Access Compliance Report

Public Rights-of-Way

| Intersection ID: 3999 | Main Street: CULLINGFORD_LN | Cross Street: AMBLESIDE_DR | Location: NW |
| ADA ID: F58512667BAD | Ramp Type: BlendTrans2 | Initial Pass/Fail: Fail | Overall Compliance: No |

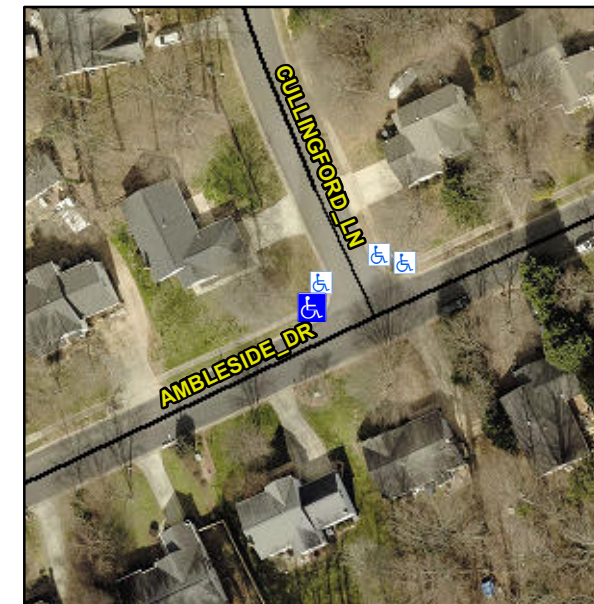
| Severity Score: 36.25 | | | |

R304.5.1

| Compliance | Description | Data | Compliance | Description | Data |
|------------|-----------------------|------|------------|-----------------------------|------|
| No | Ramp Width (in) | 30.0 | Yes | BlendTrans XSlope (%) | 2.6 |

Remove & Replace Curb Ramp With Two New Directional Ramps or Equivalent.
